Expansion Project at North Point (EF III)

**SUPPLEMENT TO FINAL DEVELOPMENT  
PLAN APPLICATION**

24 July 2017

## **COMMENTS FROM PLANNING BOARD**

Image 1 - Existing Sidewalk Analysis

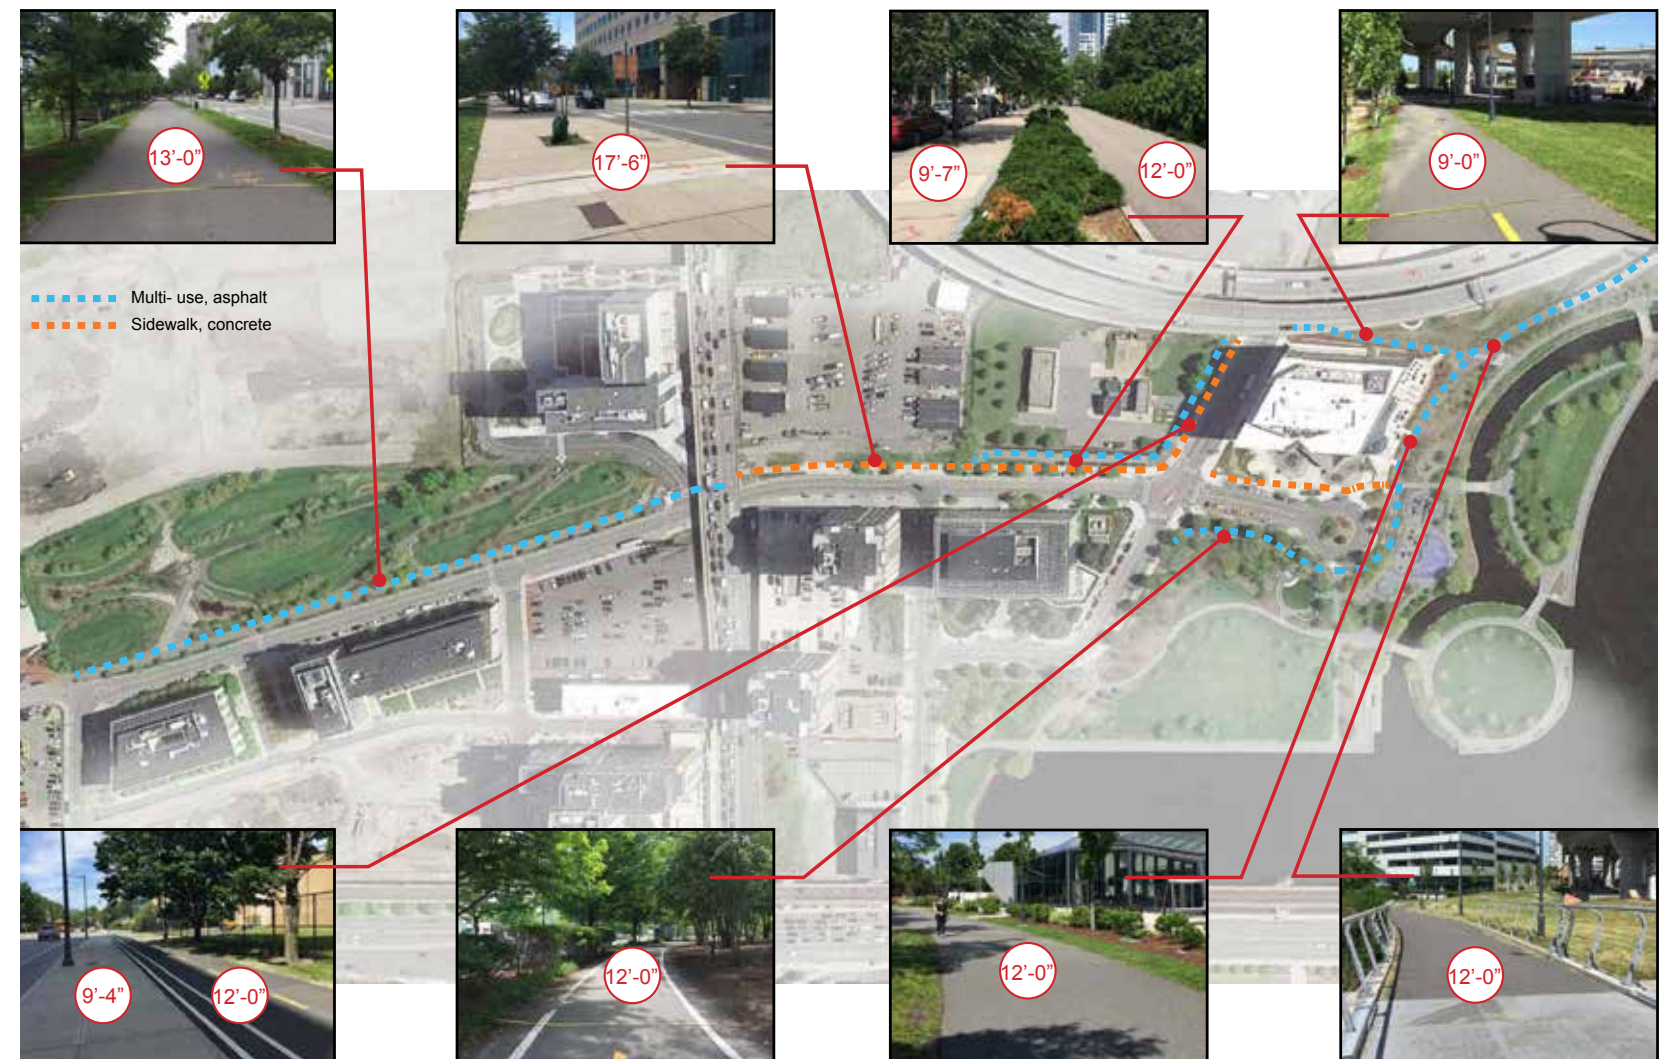
Consider alternative design approaches in order to minimize the amount of paved area along North Point Boulevard.

EF has been working closely with City staff to review and analyze the various options for the configuration of the multi-use path, sidewalk and landscape frontage along North Point Boulevard. The goal of this effort has been to minimize pavement and create an emerald necklace effect between North Point Park and the development west of the Gilmore Bridge.

Our analysis starts with an overview of the entire North Point area to identify the various dimensions and path configurations along North Point Boulevard. As illustrated here, there are inconsistent treatments to the multi-use path throughout North Point – some areas have a single path system and others have a separated sidewalk and multi-use path (See Image 1).

The western side of the Gilmore Bridge (Northpoint Project) has a 13-foot single path along North Point Boulevard. However, in front of the MWRA property and to the east of the EF III Project Site, there is a separated path system with a 12-foot multi-use path and a separate 9'-7" sidewalk.

Option A - Multi-use path and sidewalk separated by planted buffer

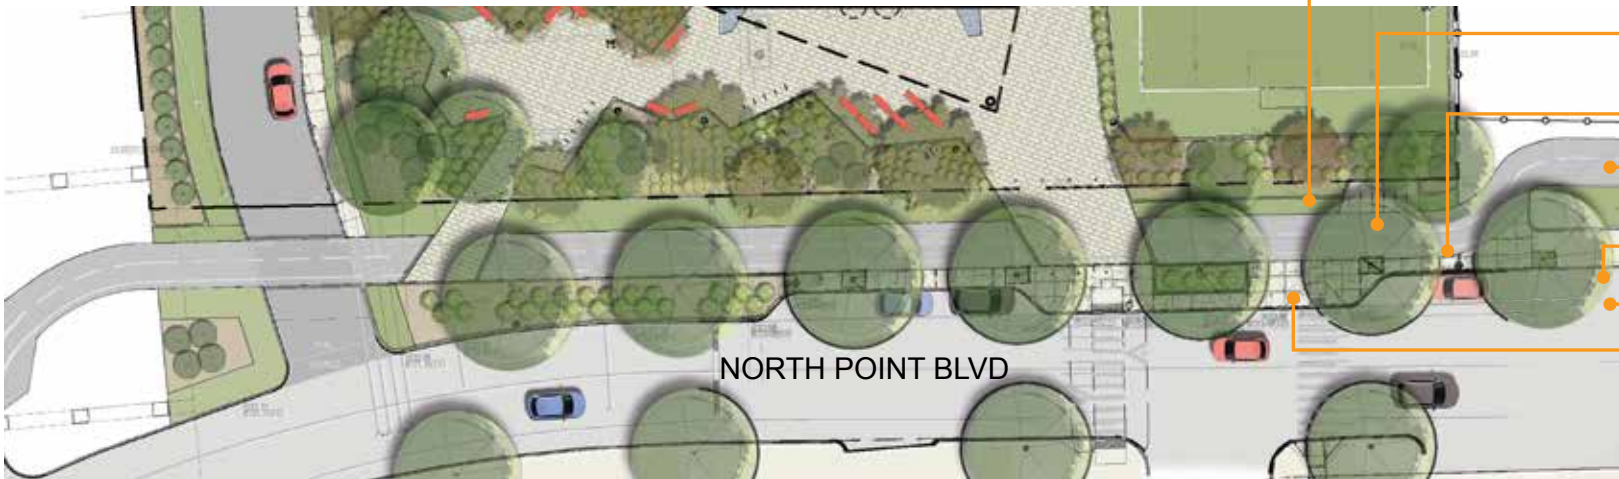
Consider alternative design approaches in order to minimize the amount of paved area along North Point Boulevard.

EF's original proposal based on meetings and site walks with CDD was to extend the treatment in front of the MWRA to across the EF III site (a two-path system consisting of a 12-foot multi-use path and a separate sidewalk). See Option A drawings and rendered view.

The Planning Board asked us to study an alternative design with a single path (consistent with the western side of the Gilmore Bridge) that would combine the sidewalk and multi-use path. Option B here shows this alternative. Although it is not in compliance with CDD's current design preference, it is consistent with the configuration on the western side of the Gilmore Bridge. After analyzing this option, we see several benefits of the single-path design, including more green space and a consistent pathway configuration for bikers and pedestrians along the longest stretch of North Point Boulevard. If the Planning Board prefers a single-path system, we would need to decide if the path is designed to CDD's current requirements or designed to be consistent with the existing conditions on the western side of the Gilmore Bridge.

We defer to the Planning Board on whether we build Option A (a two-path system) or Option B (a single path system).

Option A- Section

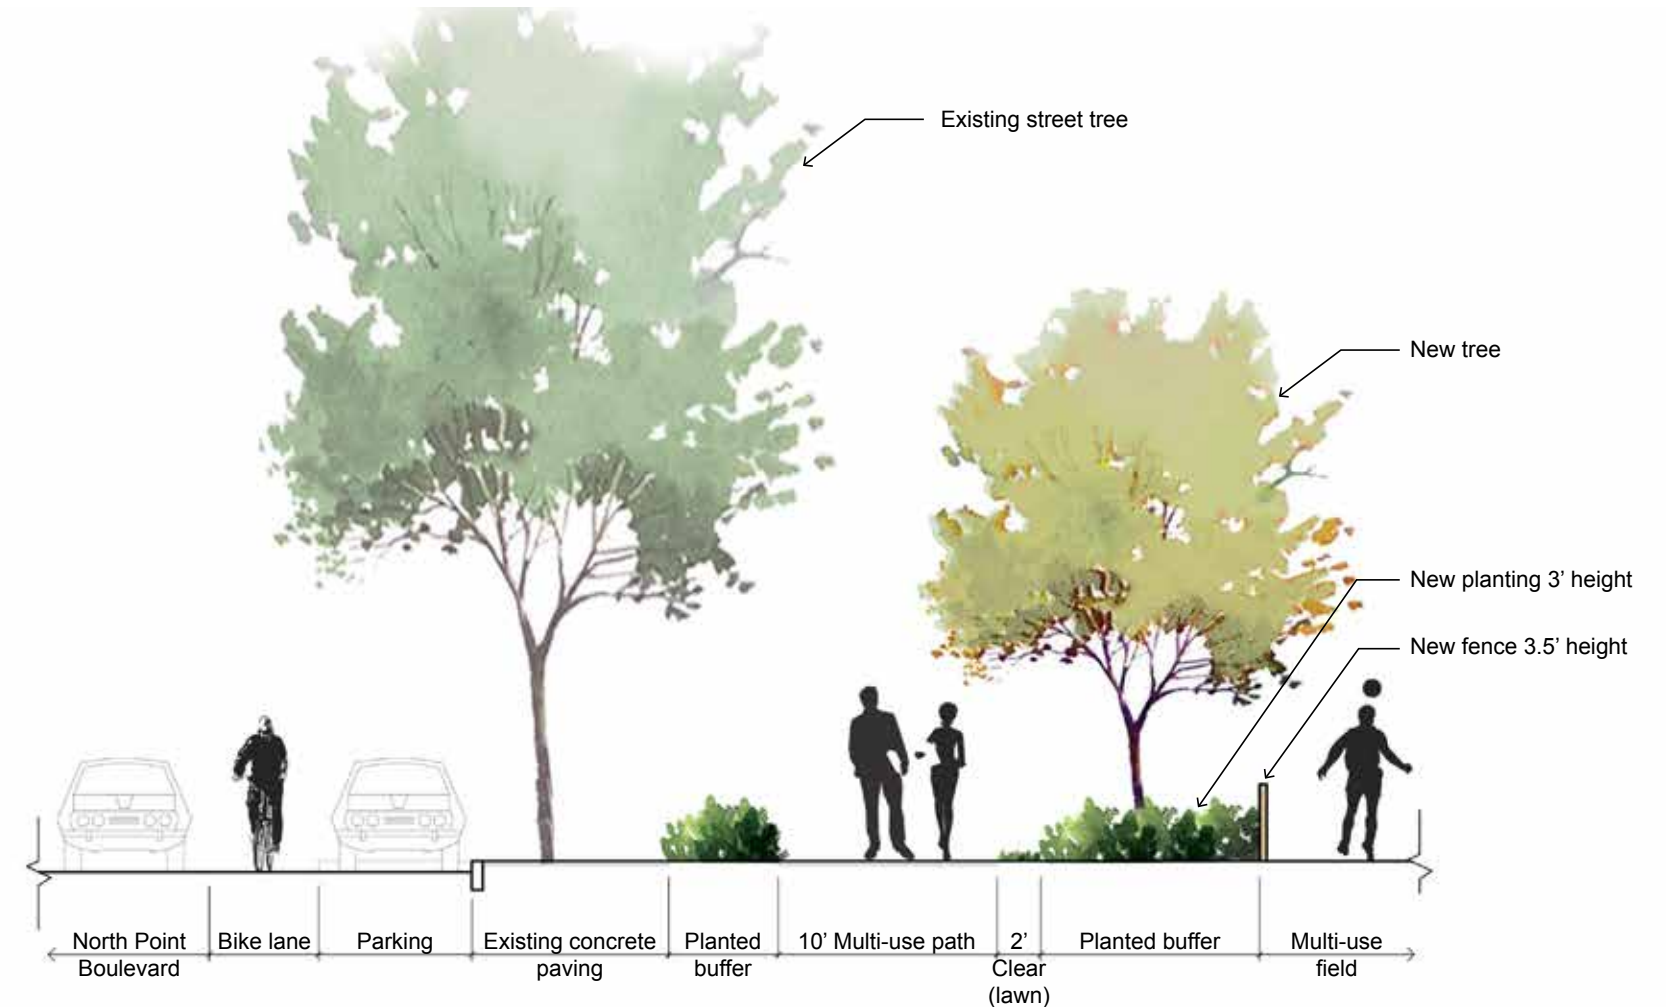
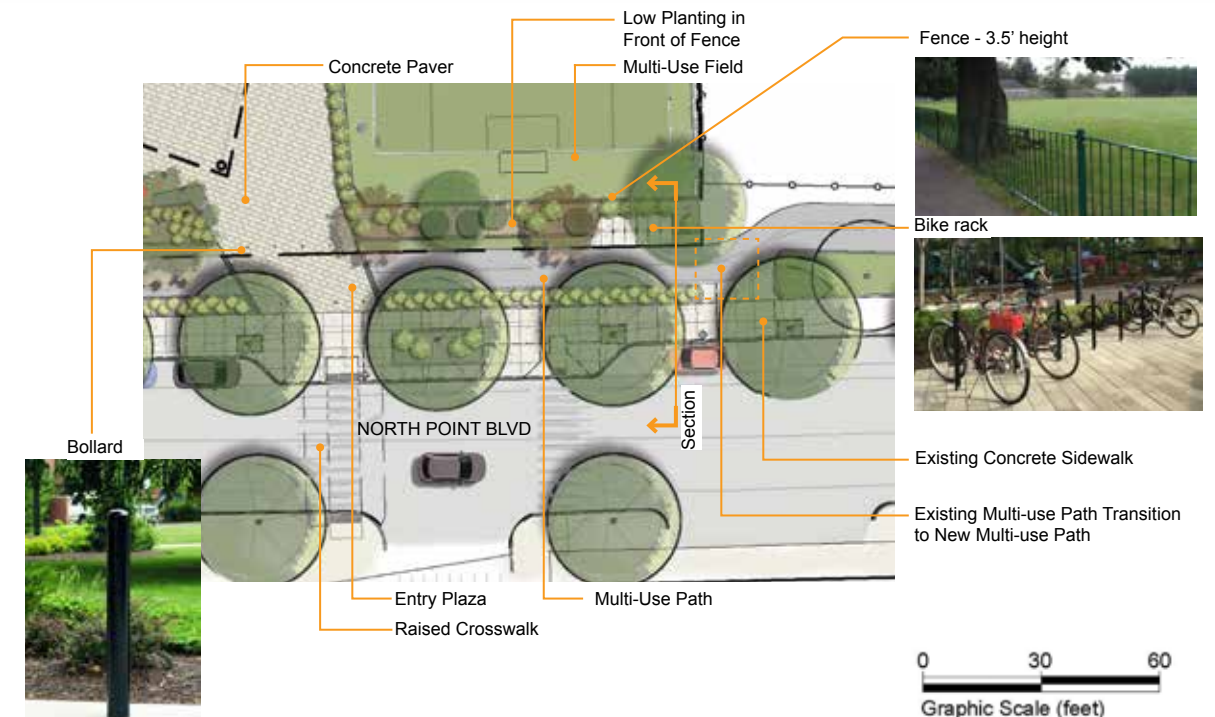
Provide details of the proposed fence treatment around the multi-use field.

The first fence is located along the MWRA property line and abuts the multi-use field. It is an existing chain link fence that will remain to provide a boundary between the MWRA and EF III sites. As suggested in Public Comment at the Planning Board Hearing, EF will plant flowers and ivy along the existing MWRA fence.

The second fence has been the result of trying to activate the outdoor public realm (specifically the multi-use field) while also protect passersby and park users from game balls. After studying various options, EF proposes a 3.5-foot metal fence that will be installed along North Point Boulevard in front of the multi-use field and then extend along the western side of the multi-use field to the Central Plaza area. It will have nicely landscaped plantings on one sides and blend in with the overall look and feel of the outdoor public realm. EF agrees to work closely with CDD on the final design and configuration of the multi-use field fence in a design-review process.

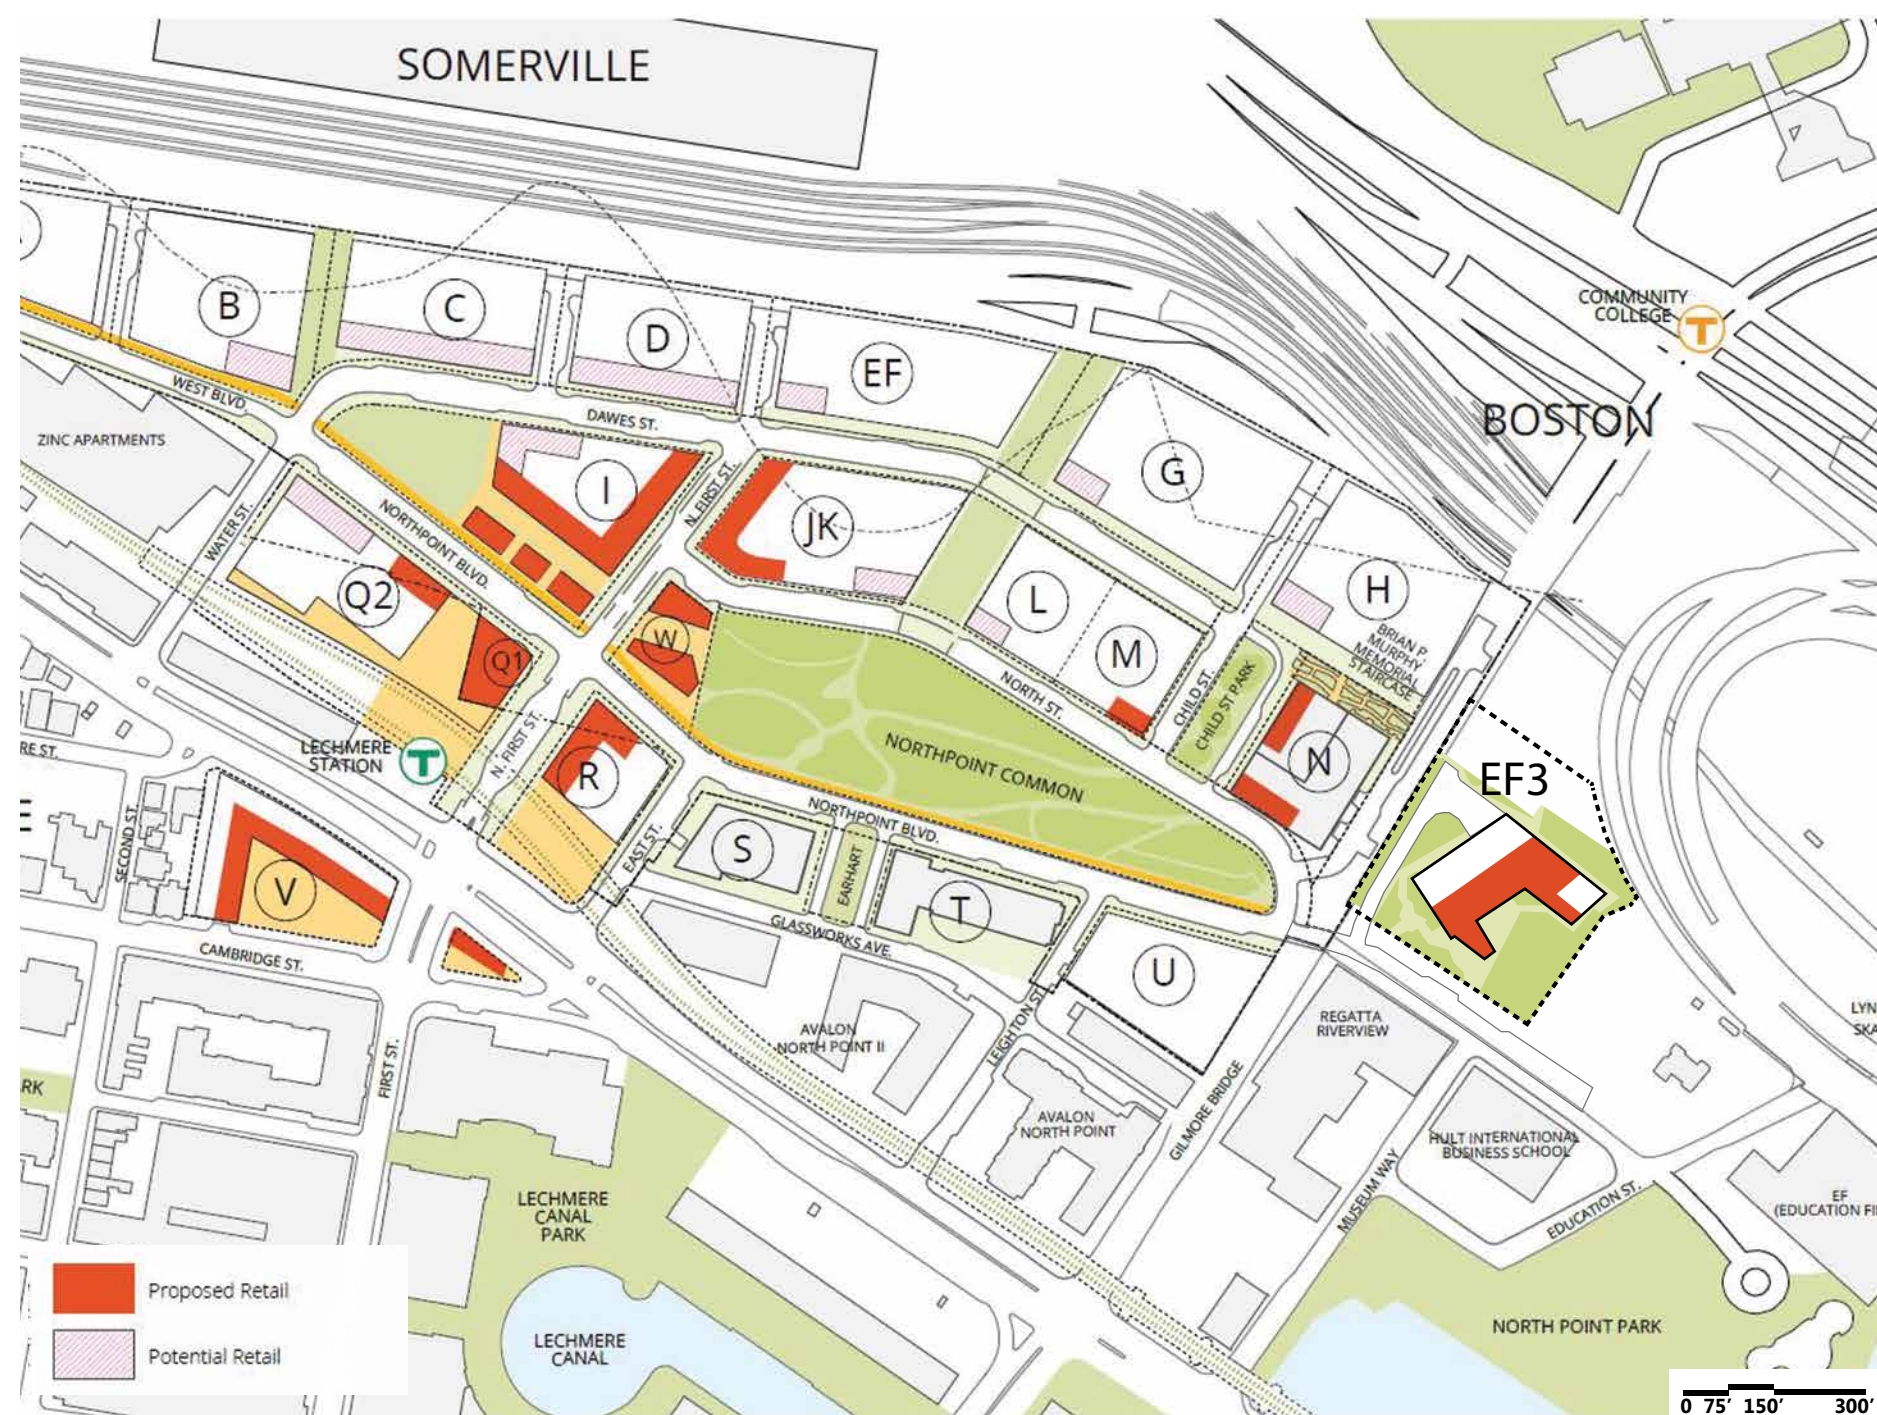
Consider the arrangement of benches and flexible seating options, including movable outdoor furniture.

EF is proposing a robust outdoor seating area with many flexible options for park users and members of the public. The main seating areas will be the Central Plaza area overlooking the multi-use field and the West Park area that provides a shaded passive recreation area.

Seating options include colorful benches, seating with and without backs and movable table-chair furniture pieces, some of which are illustrated here.
